Technical change to module RS F10 I/O8 LD LPK2

PCN-number: 20240509

DEKAFIX detail

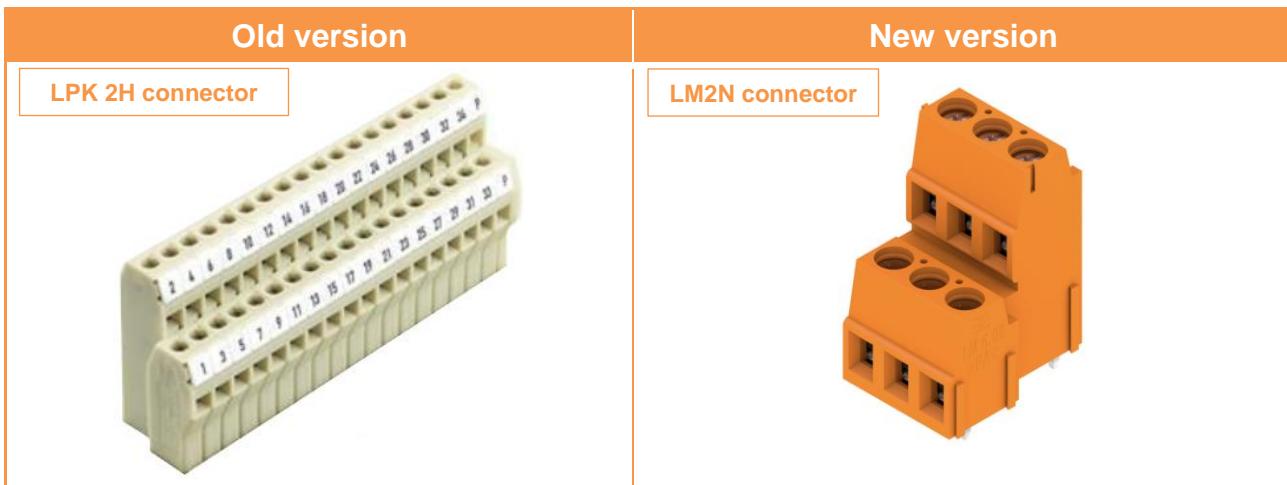
The article on Section 5 was delivered in the past with LPK connectors. Furthermore, it was delivered with Dekafix*

*Dekafix is the universal marker for terminals, plug-in connectors, and electronic modules from the Weidmüller product range (see detail).

Based on continuous improvement the LPK connectors will be replaced by LM2N connectors with Tampoprint.
